HISTORIC AND DESIGN REVIEW COMMISSION

HDRC CASE NO: 2019-752
ADDRESS: 3331 ROOSEVELT AVE
LEGAL DESCRIPTION: NCB 11911 BLK 7 LOT 39 (LUFKIN HILL SUBD)
ZONING: C-2, H, MPOD-2
CITY COUNCIL DIST.: 3
DISTRICT: Mission Historic District
APPLICANT: xavier gonzalez/grg architecture
OWNER: Arthur Garcis/R&A GARCIA PROPERTIES OF LUFKIN LLC
TYPE OF WORK: Construction of a commercial structure
APPLICATION RECEIVED: December 19, 2019
60-DAY REVIEW: February 17, 2020
CASE MANAGER: Edward Hall
REQUEST:

The applicant is requesting conceptual approval to construct a commercial structure at 3331 Roosevelt Avenue, located within the Mission Historic District. The proposed new construction will feature both interior and exterior dining space, and surface parking for approximately 200 automobiles.

PRELIMINARY SITE PLAN

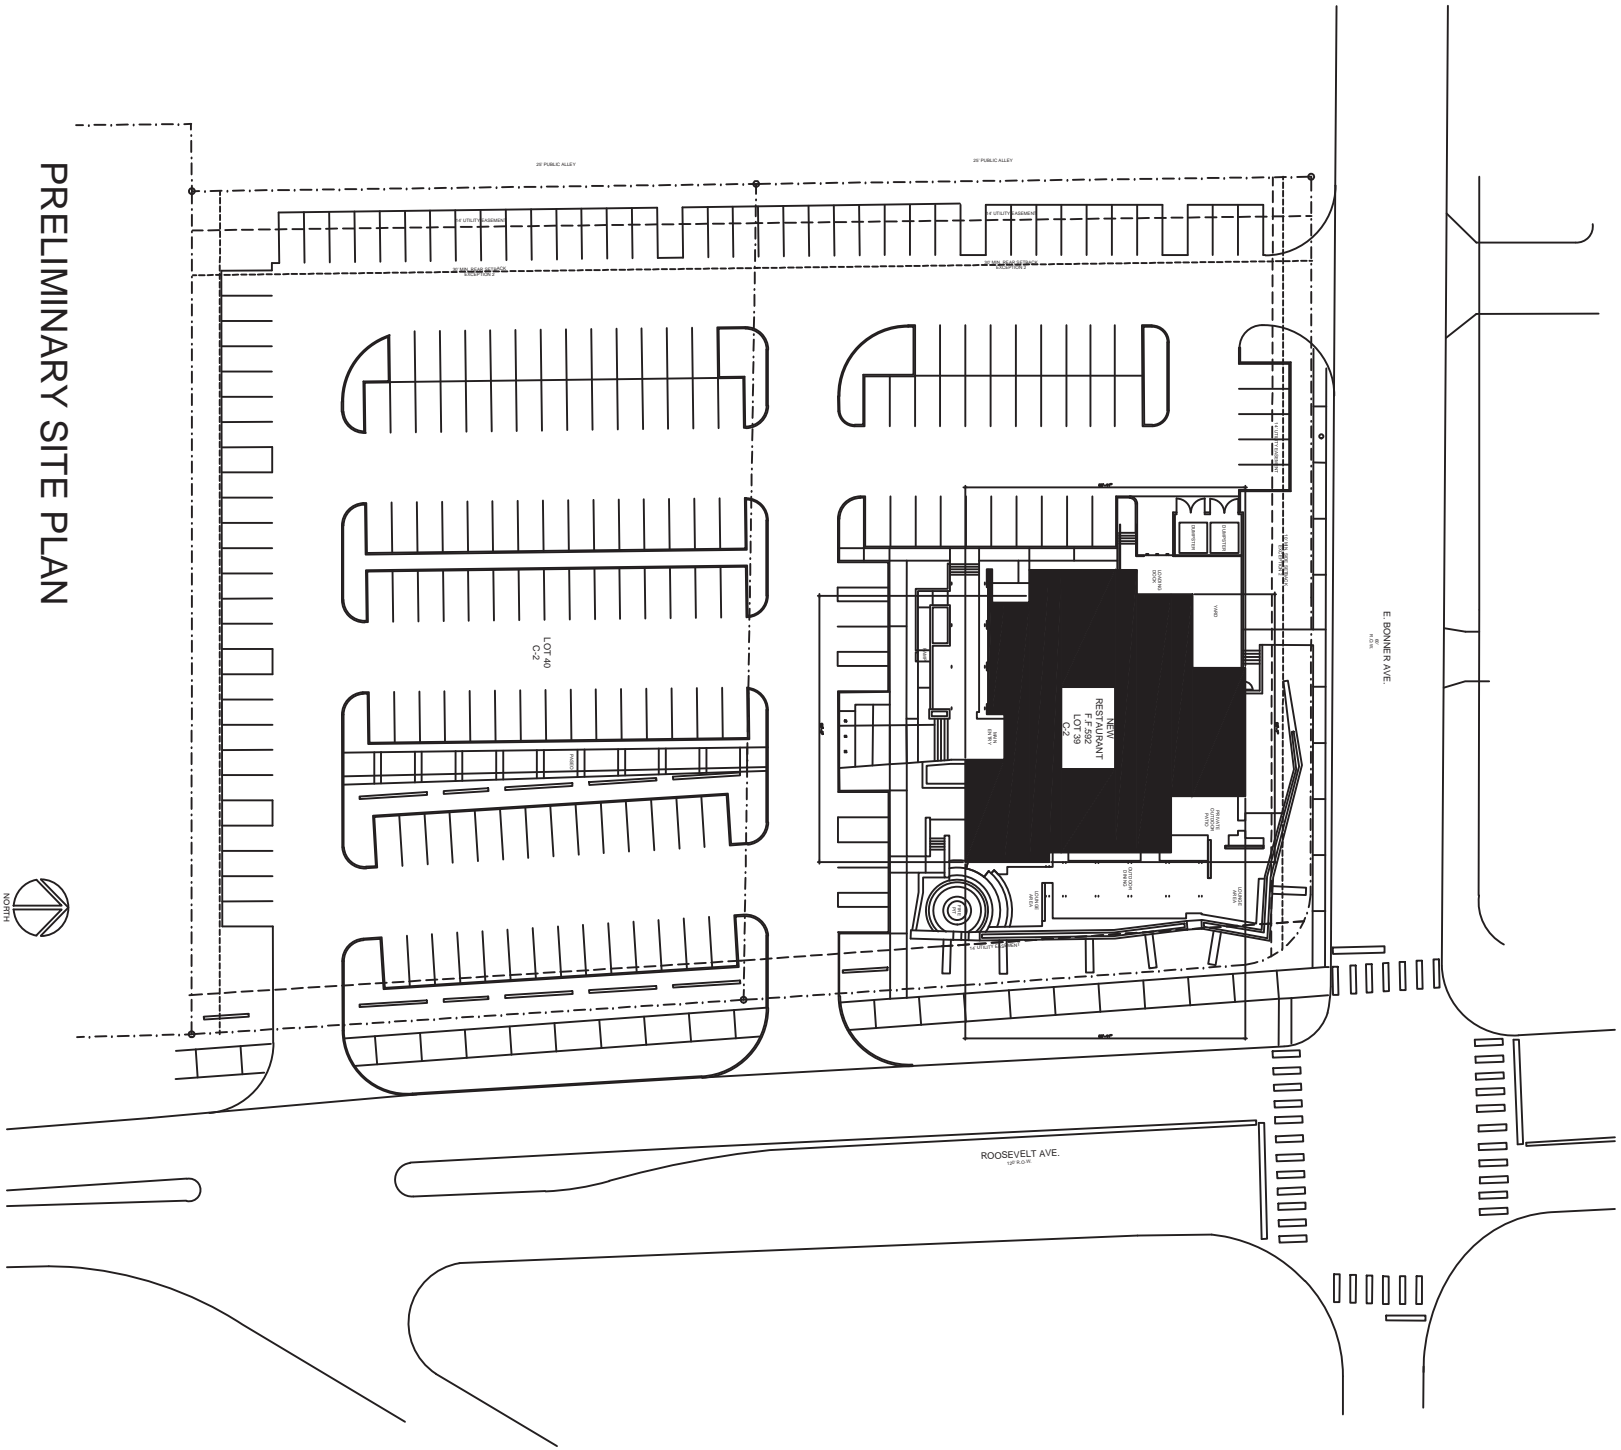
- g. PARKING LOCATION – Per the Mission Design Manual, rear and side parking is encouraged for development north of SE Military Drive. The applicant has proposed parking for approximately 200 automobiles to the rear and side (west and south) of the proposed new construction. While this is consistent with the Mission Design Manual, staff finds that a landscaping buffer should be included for parking that is proposed adjacent to the public right of way, on both Roosevelt and Bonner. The proposed landscaping buffer should be consistent with that which is proposed parallel to the proposed structure. Additionally, staff finds that documentation should be submitted to staff that necessitates the proposed amount of parking.

- h. VEHICULAR ACCESS – The applicant has proposed a total of three (3) curb cuts on the site; two on Roosevelt and one on Bonner. In general, driveway widths should not exceed 24', per the Mission Design Manual. Staff finds that the applicant should consider the elimination of a curb cut on Roosevelt. The applicant is responsible for complying with the Mission Design Manual regarding driveway and curb cut widths.

- n. LANDSCAPING – The applicant has submitted a rendered site plan noting general locations and types of landscaping materials. Generally, staff finds this to be appropriate; however, when returning to the Commission for final approval, the applicant should submit a detailed landscaping plan for review and approval. Additionally, as noted in finding g, staff finds that additional buffering elements should be incorporated into the landscape design along Roosevelt and Bonner to screen the proposed surface parking lot from the right of way.

- i. That the applicant incorporate additional landscaping elements to buffer the proposed surface parking from the right of way at Roosevelt and Bonner as noted in finding g.

- ii. That the applicant ensure that no curb cut exceeds more than twenty-four (24) feet in width as noted in finding h.
- iii. That metal windows featuring dark frames be used that are installed at least two (2) inches within all façade openings as noted in finding l.

- iv. That a detailed landscaping plan be submitted for review and approval when returning to the Commission for final approval as noted in finding n.
- v. That a detailed signage plan be submitted for review and approval when returning to the Commission for final approval as noted in finding o.
